Contract #: 04-0120F4Cty: SF/ALA Rte: 80 PM: 13.2/13.9File #: 69.25B**QUALITY ASSURANCE -- NON-CONFORMANCE REPORT****Location:** Changxing Island, Shanghai, P.R. China**Report No:** NCR-000295**Prime Contractor:** American Bridge/Fluor Enterprises, a JV**Date:** 03-Jun-2009**Submitting Contractor:** Zhenhua Port Machinery Company, Ltd (ZPMC), Changxing Island**NCR #:** ZPMC-0269**Type of problem:**

Reference Description: Improper Weld Joint Cleaning, Segment 4BE**Description of Non-Conformance:**

Job Name: SAS Superstructure

Subject: NCR No. ZPMC-0269

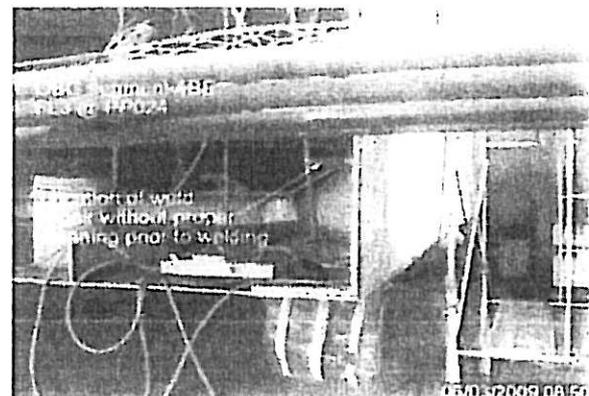
Caltrans Quality Assurance (QA) Inspector observed the Contractor perform base metal edge weld repair without cleaning and removing slag prior to welding. The part was identified as X82V and located on Floor Beam FB018A (FL3, PP026, OBG Segment 4BE).

AWS D1.5 2002 section 3.7.1... "The surface shall be thoroughly cleaned before welding."
